SUBJECT: Mooney Aircraft With Smooth Skin Elevators and Balance Weight Inspection
[Chapter 27 - FLIGHT CONTROLS]

MODELS/ SN AFFECTED: All Mooney Models with smooth skin (non-beaded) elevators

Figure SBM20-345-1 - SMOOTH SKIN ELEVATOR AND BALANCE WEIGHT IDENTIFICATION

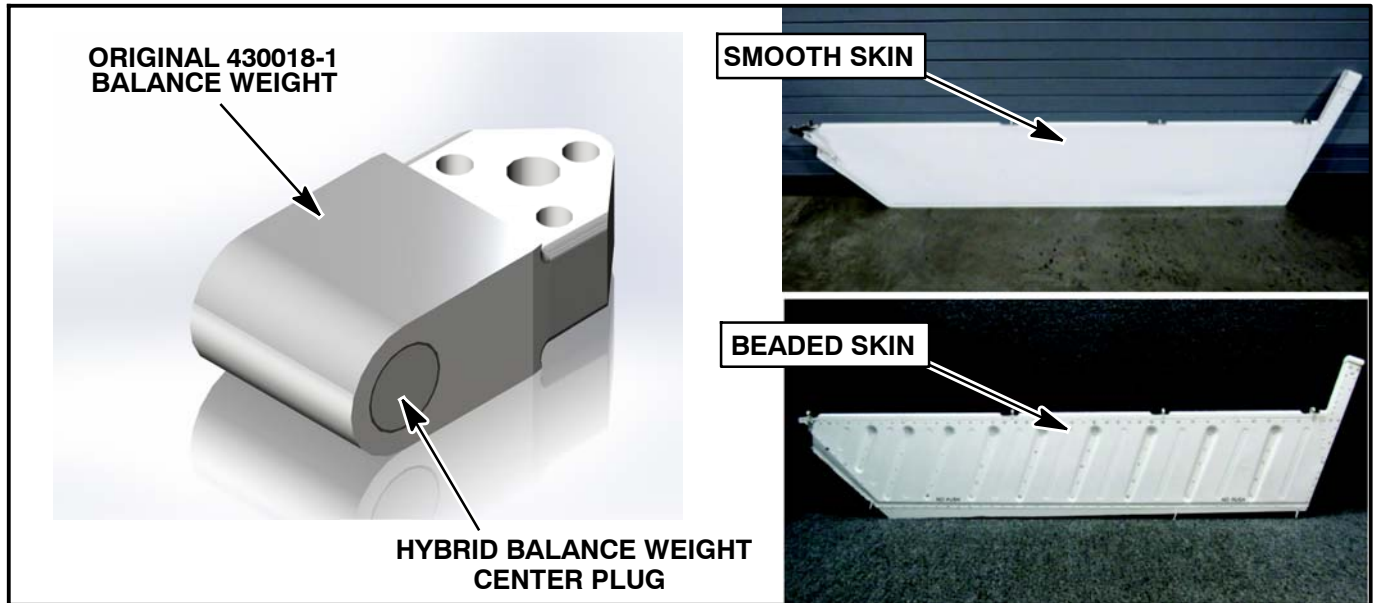
- 1.1. If cracks occur, they will most likely be the outer material surrounding center plug, refer to **Figure SBM20-345-1 and SBM20-345-2.**
- 1.2. Inspect all areas of the elevator balance weight for any abnormalities, refer to **Figure SBM20-345-2.** If required, remove paint from the area to be inspected.

If during visual inspection it is determined that both elevator balance weights are not the Hybrid 430018-1 balance weight, no further inspections are required.

Figure SBM20-345-2 - ABNORMALITIES - SEVERE GALVANIC CORROSION AND CRACKING OF THE ORIGINAL 430018-1 BALANCE WEIGHT

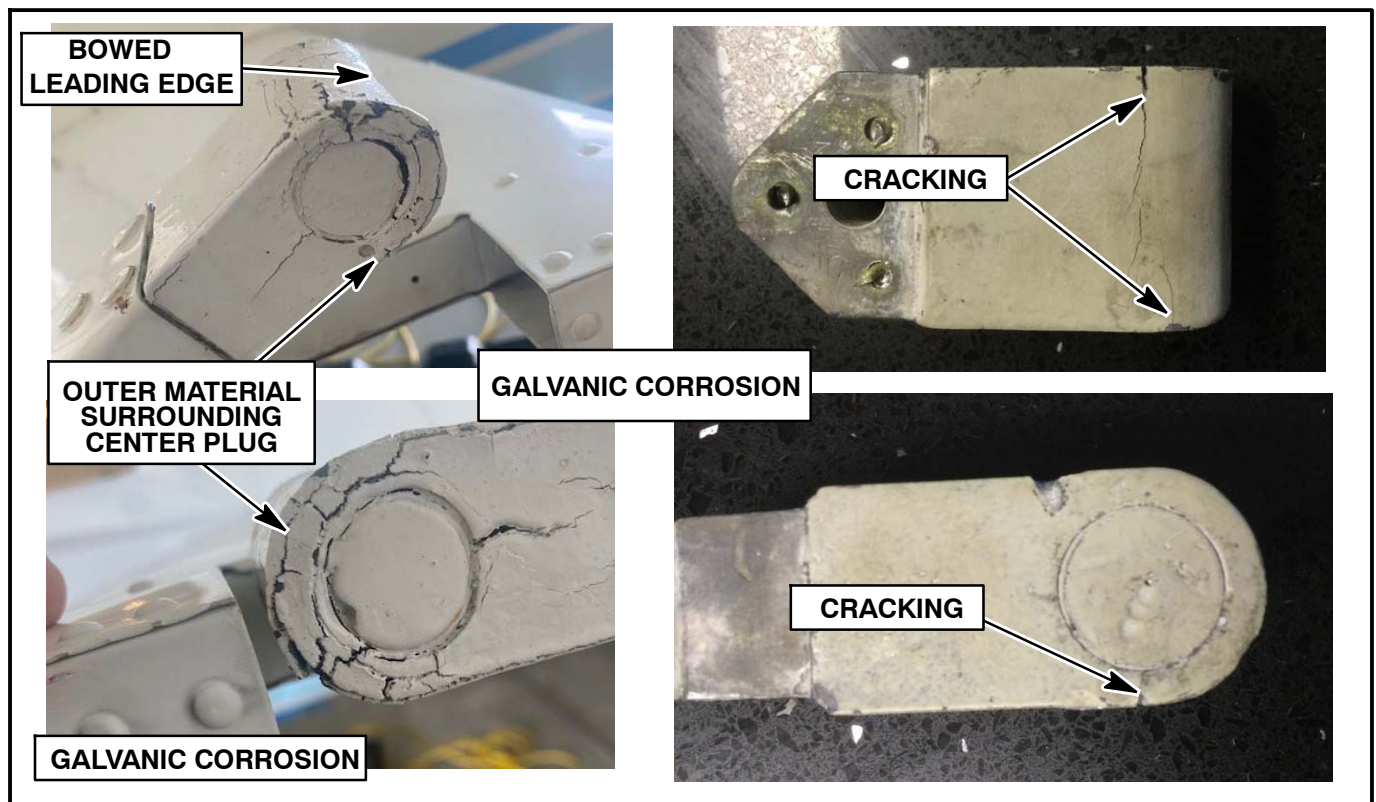
- 1.3. If the balance weight is found to be "abnormal" - DO NOT FLY - Please contact Mooney Technical Support at email technicalsupport@mooney.com for further instructions.

If elevator balance weights are the original 430018-1 style, DO NOT FLY, the balance weights will need to be replaced with new weights developed by Mooney in a later revision of this Service Bulletin.
